Town of Hilton Head Island

Design Review Board Meeting

Tuesday, September 10, 2024, 2:30 PM

**1014 William Hilton
Parkway
PLAN SET**

PARTIAL EXISTING RIGHT SIDE ELEVATION
SCALE: 1/4" = 1' - 0"

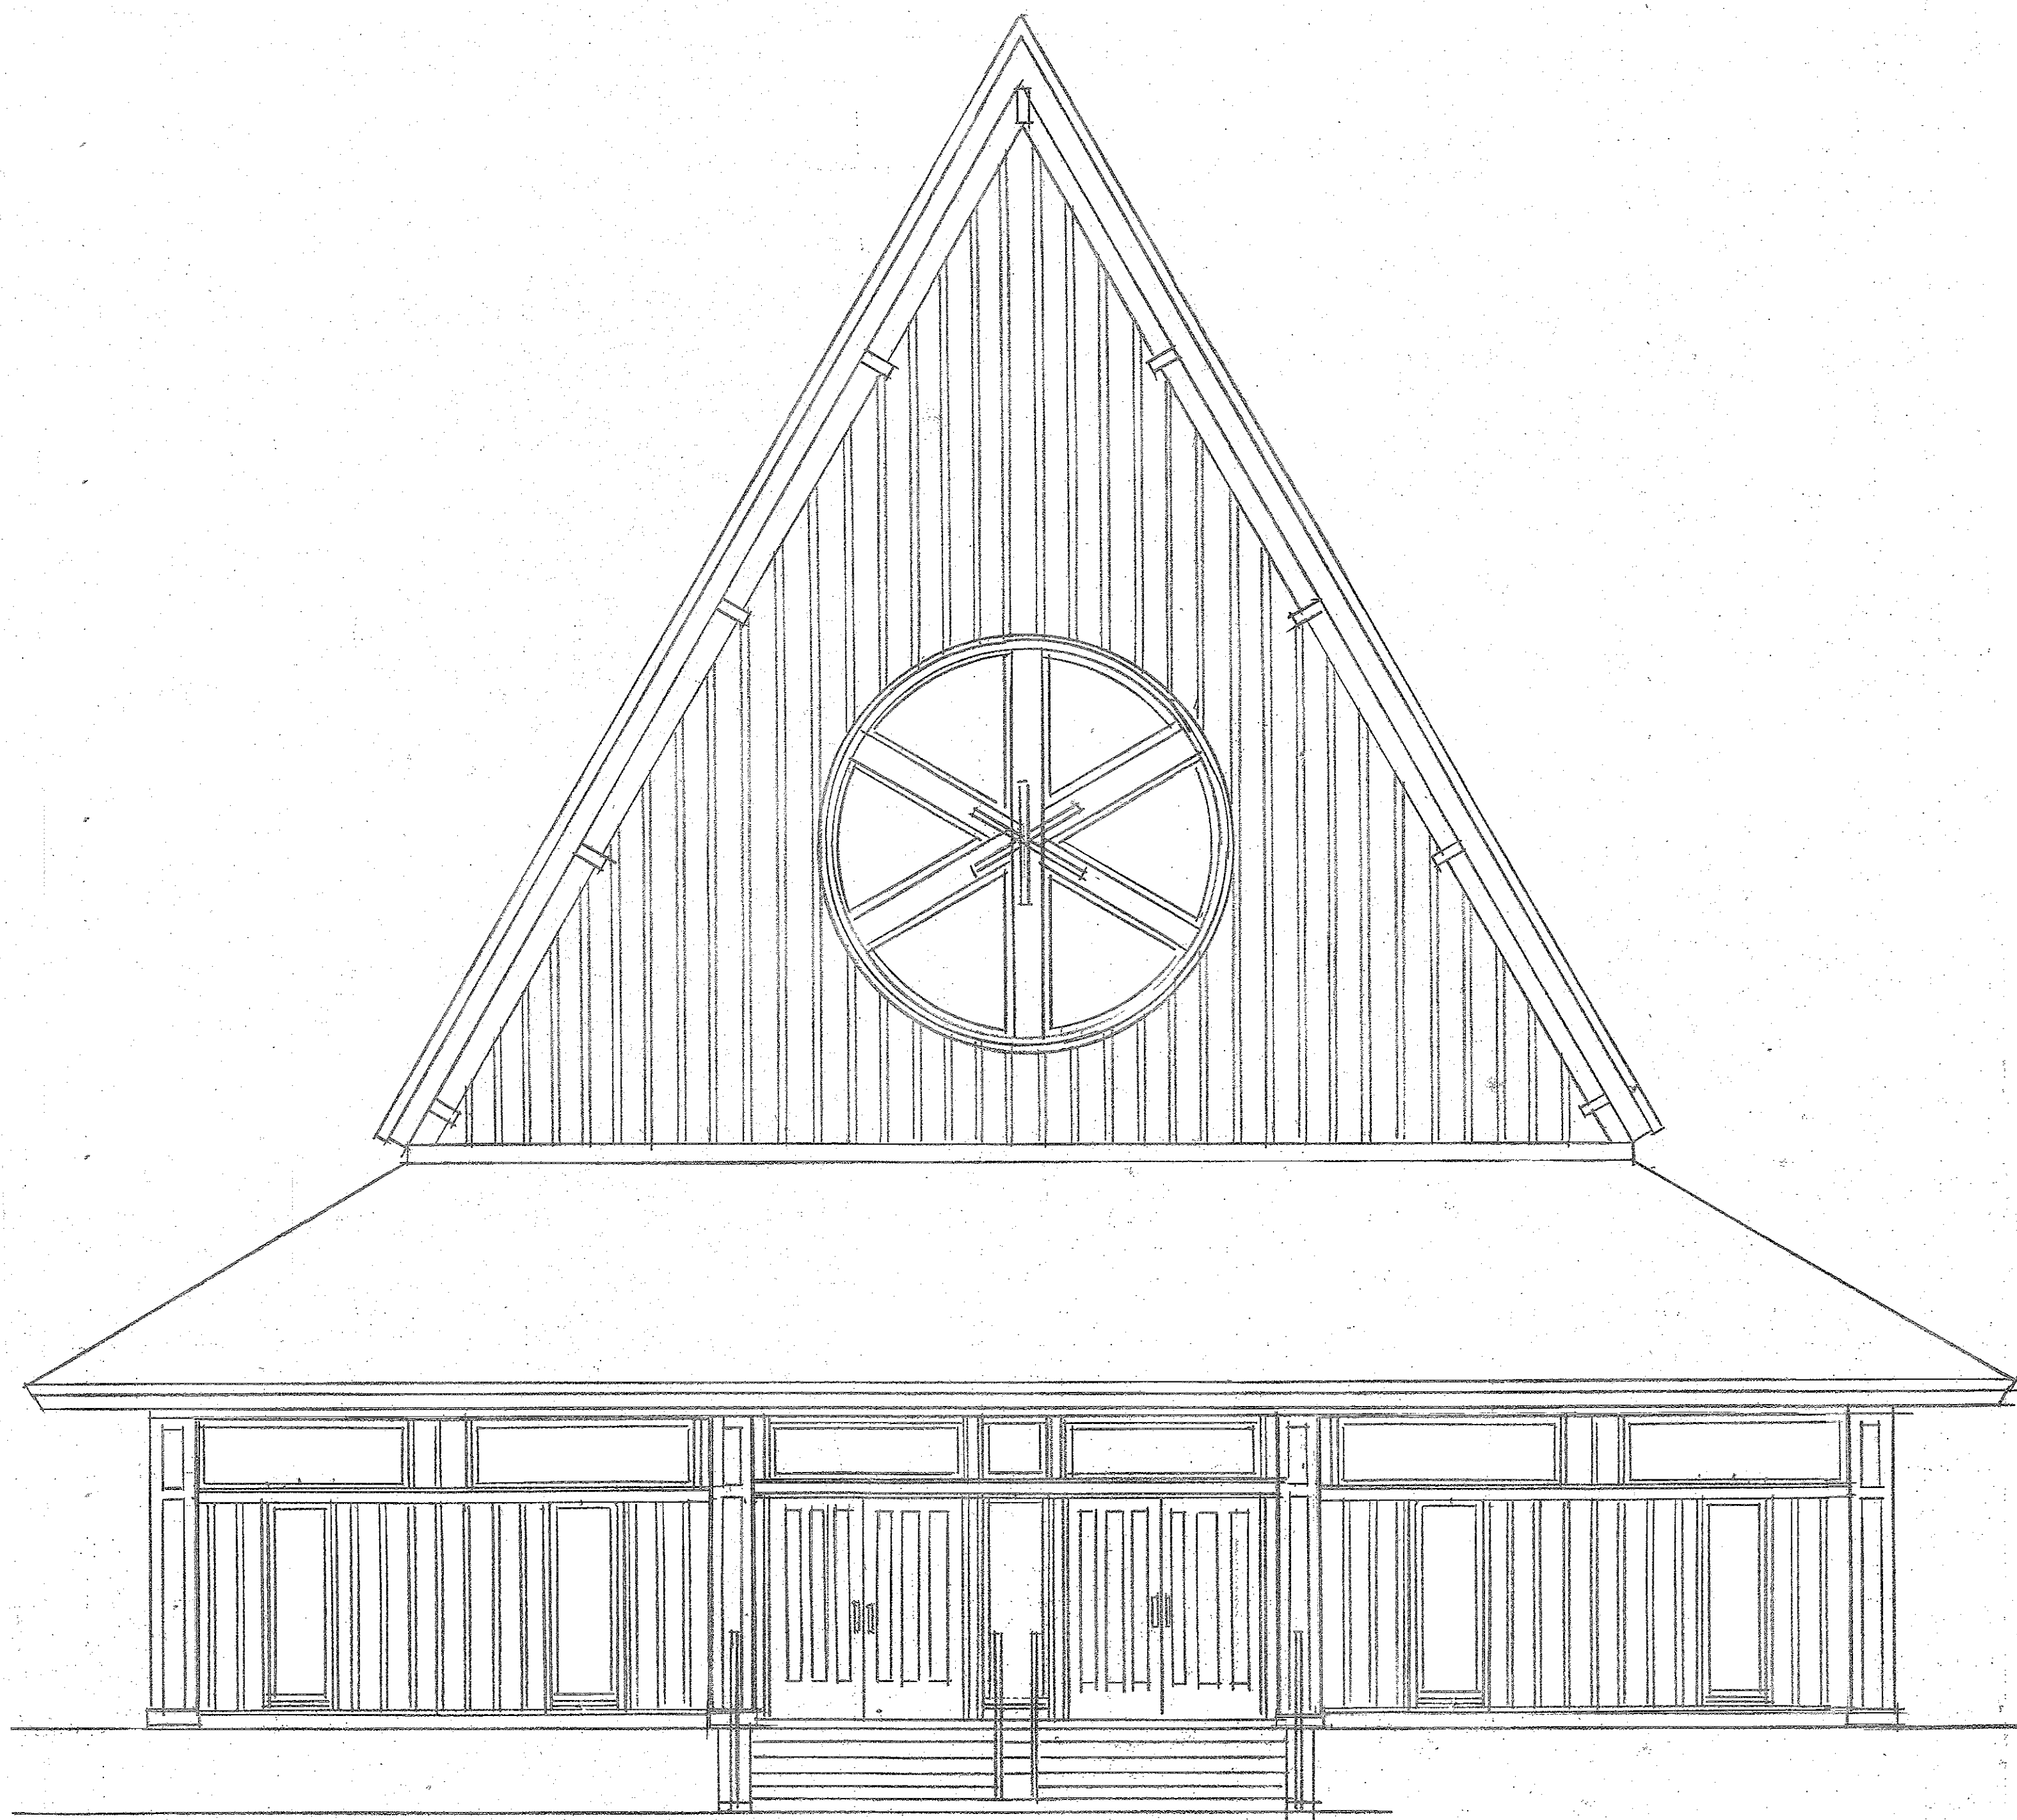
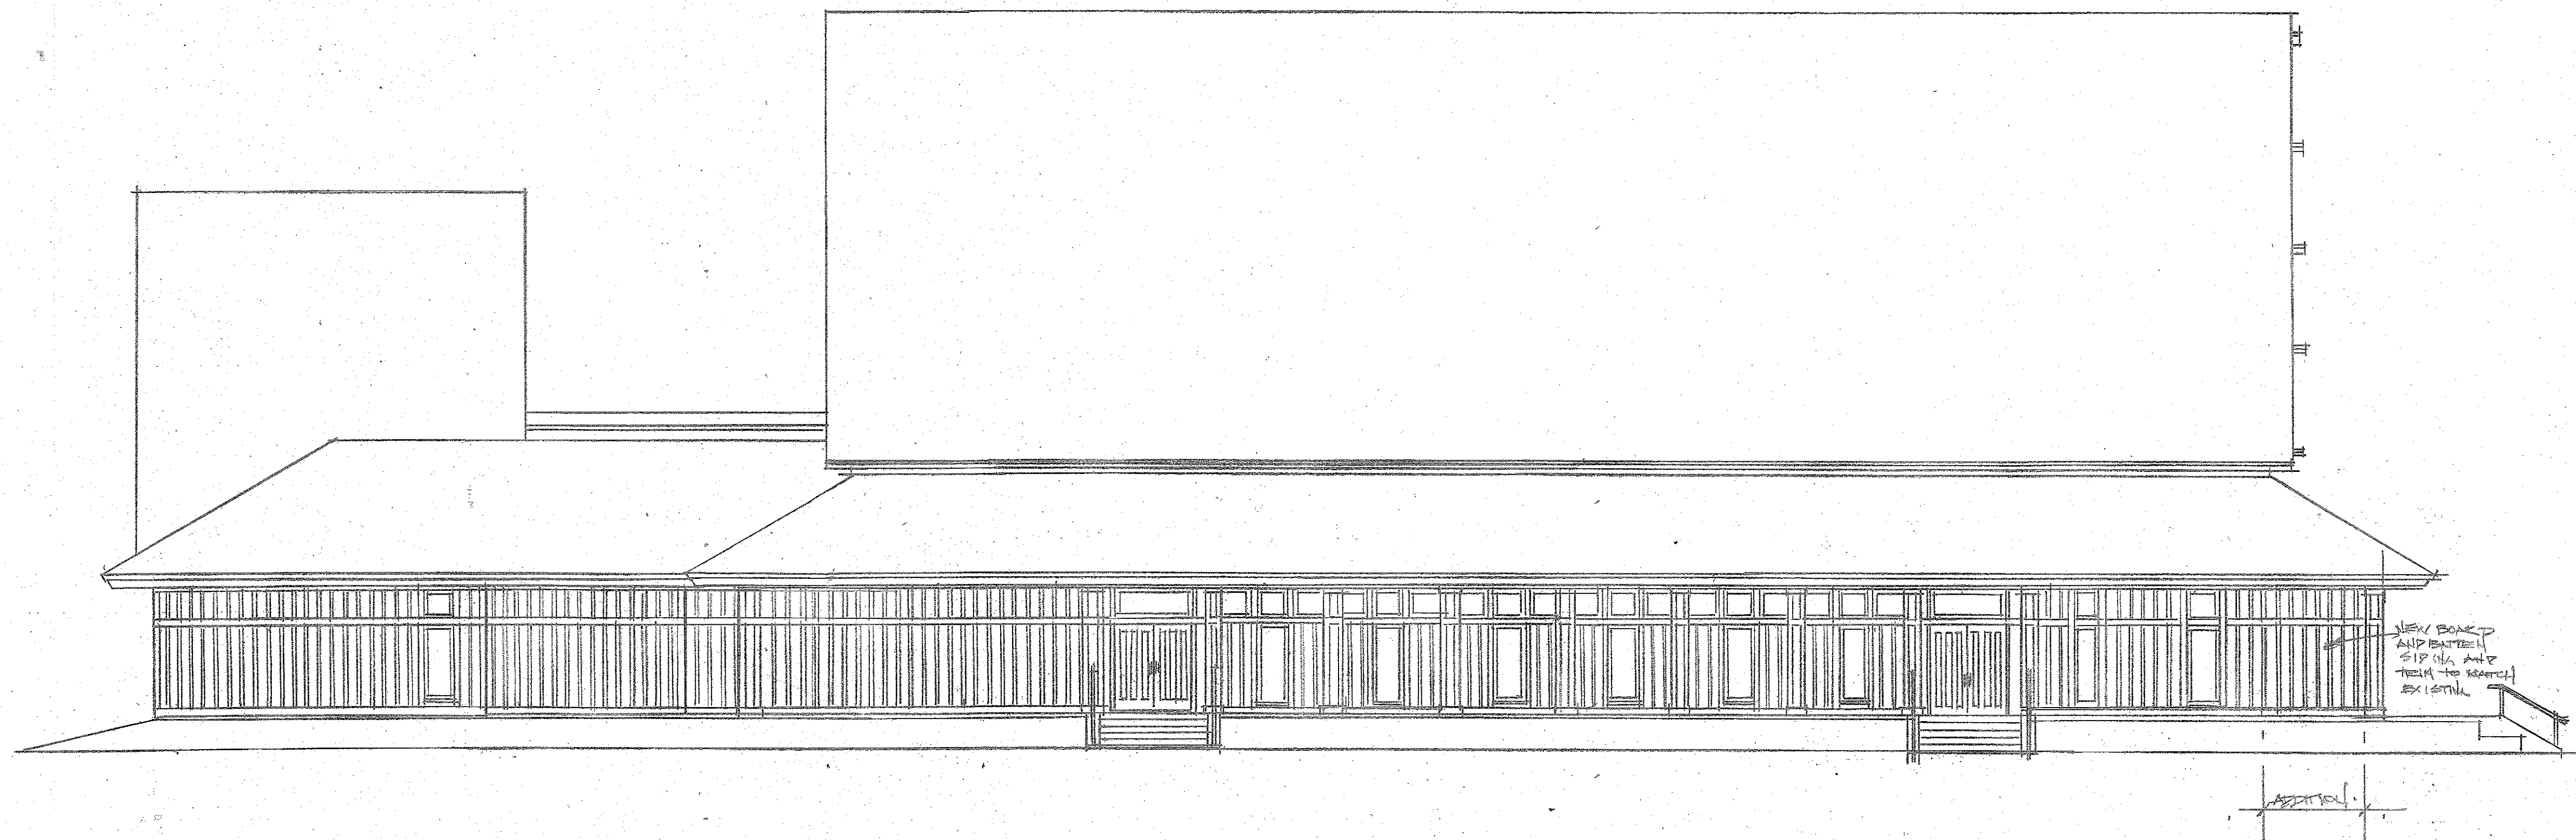
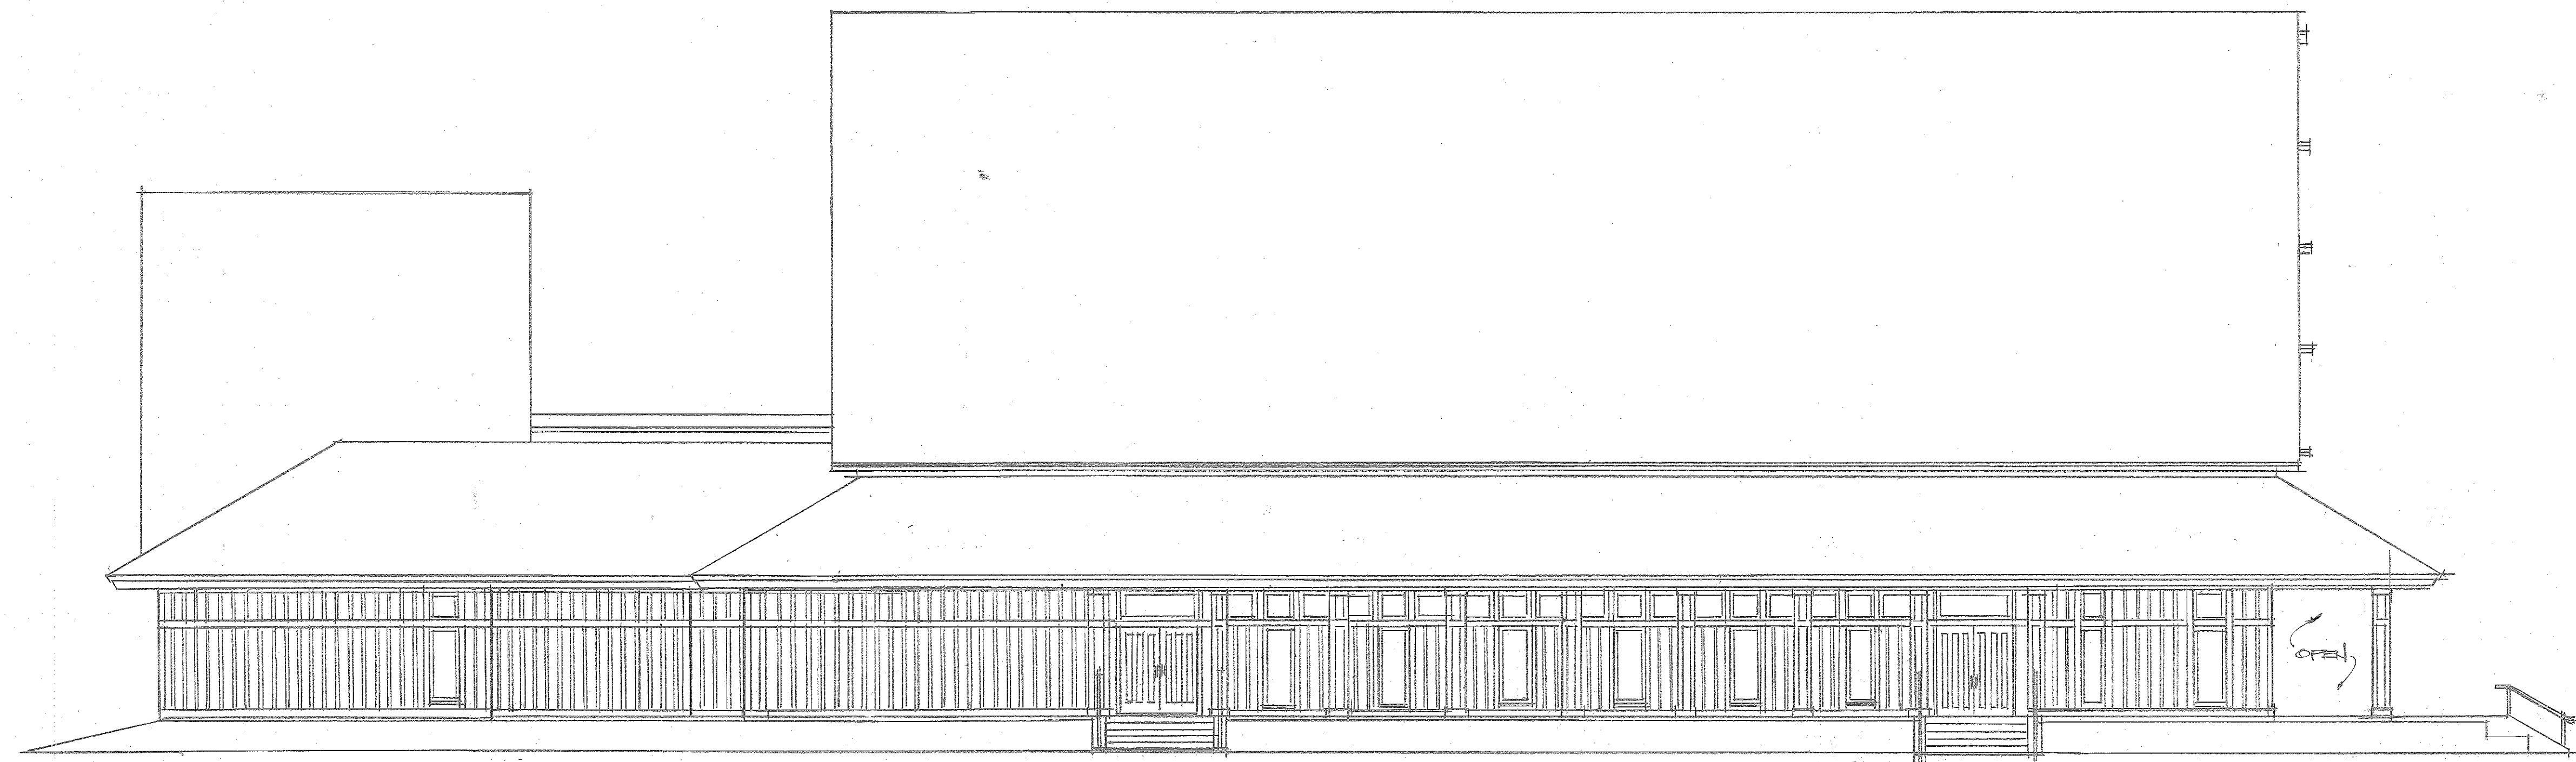
DRB REQUIREMENTS	Complies Yes	No	Not Applicable	Comments or Conditions
Demolition Plan if needed	☒	☐	☐	
Existing Conditions match As-Built	☐	☒	☐	The proposal is to construct bathrooms with A.D.A. handicap facilities for the church sanctuary.
Dimensioned Details and of Sections	☐	☐	☒	Provide dimensions on plans, elevations and sections for Final Review.
Detail Illustrating Connection to Existing Structure	☐	☐	☒	The proposed mural will be painted on an existing brick wall.
New Building Details Match Existing Building Details	☐	☐	☒

DESIGN GUIDE/LMO CRITERIA	Complies Yes	No	Not Applicable	Comments or Conditions
Structure is designed to be appropriate to the neighborhood	☒	☐	☐	
Promotes pedestrian scale and circulation	☒	☐	☐	
Design is unobtrusive and set into the natural environment	☒	☐	☐	
Utilizes natural materials and colors	☒	☐	☐	Provide a 11 x 17 Materials Board for final review.

Avoids distinctive vernacular styles	☒	☐	☐	
Design is appropriate for its use	☒	☐	☐	
All facades shall have equal design characteristics	☒	☐	☐	
Avoids monotonous planes or unrelieved repetition	☒	☐	☐	
Has a strong roof form with enough variety to provide visual interest	☒	☐	☐	
Overhangs are sufficient for the façade height.	☒	☐	☐	
Forms and details are sufficient to reduce the mass of the structure	☒	☐	☐	
Human scale is achieved by the use of proper proportions and architectural elements	☒	☐	☐	
Utilizes a variety of materials, textures and colors	☒	☐	☐	A 11x 17 materials board is required for final review.
Incorporates wood or wood simulating materials	☒	☐	☐	
Windows are in proportion to the facade	☐	☐	☒	
Details are clean, simple and appropriate while avoiding excessive ornamentation	☐	☒	☐	Provide details for final review.
Utilities and equipment are concealed from view	☐	☐	☒	
Decorative lighting is limited and low wattage and adds to the visual character	☐	☒	☐	Any exterior lighting for the bathroom addition shall be submitted for final review.

Accessory elements are designed to coordinate with the primary structure	☐	☒	☐	Provide any exterior elements of the addition to coordinate with the primary structure for final review.

LANDSCAPE DESIGN				
DESIGN GUIDE/LMO CRITERIA	Complies Yes	No	Not Applicable	Comments or Conditions
Treats the Landscape as a major element of the project	☐	☒	☐	Provide a landscape plan indicating the existing and proposed landscaping around the addition.
Provides Landscaping of a scope and size that is in proportion to the scale of the development	☐	☐	☒	
Landscape is designed so that it may be maintained in its natural shape and size	☐	☐	☒	
Preserves a variety of existing native trees and shrubs	☐	☐	☒	
Provides for a harmonious setting for the site's structures, parking areas or other construction	☒	☐	☐	
Location of existing trees and new trees provides street buffers, mitigation for parking lots, and an architectural complement that visually mitigates between parking lots and building(s)	☐	☐	☒	
Shrubs are selected to complement the natural setting, provide visual interest and screen less-desirable	☐	☐	☒

1. Staff recommends approval of the addition with the following conditions to be provided prior to the Final submittal:
 - a. Physical Material and Color Board on a 11”x17” - ask for example if needed
 - b. Provide dimensions on plans, elevations and sections.
 - c. Provide any lighting specs that will be used at the exterior of the addition.

| <ul style="list-style-type: none">d. If you are using exterior lights, provide a lighting plan for final review.e. Provide a landscape plan for any proposed planting around the exterior of the addition.f. Provide a Boundary Survey. <p>2. Any additional information as required by the Board.</p> |
